## Rear Shelf Speaker Aperture Modification

Tony Johnson  
Chief Executive Officer  
**Low Volume Vehicle Technical Association, Inc**

### Early Nissan Bluebird

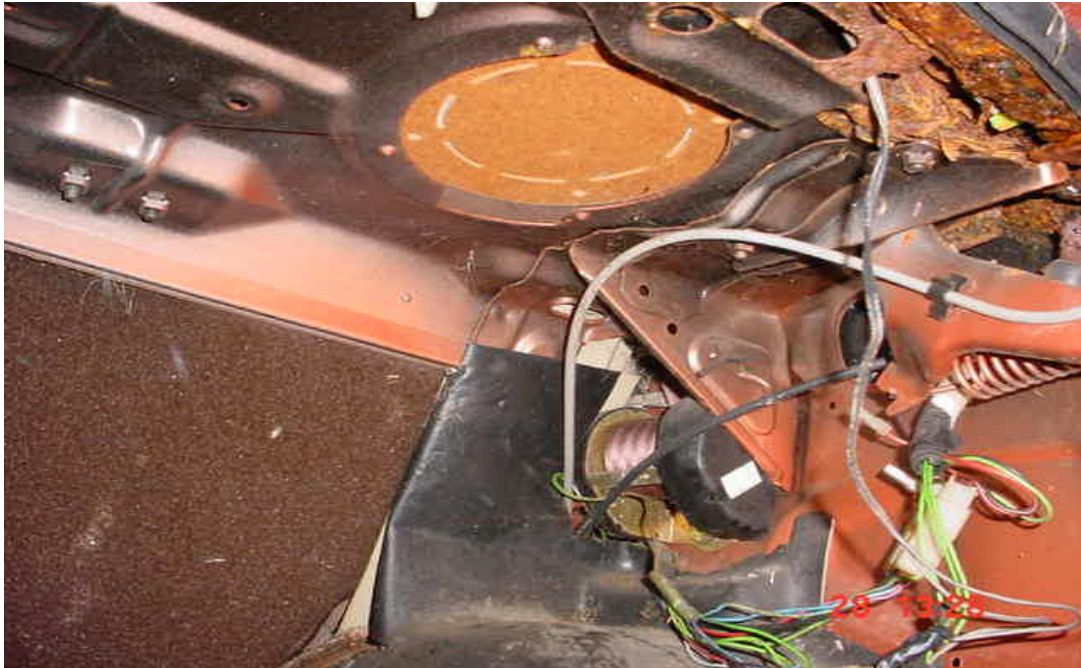
This Nissan Bluebird static anchorage would pull forwards on the C-pillar and inwards during an impact. The sheet metal structure forming the rear of the seat would still provide support to the C-pillar's inward loading, even if the rear shelf speaker aperture were to be enlarged.
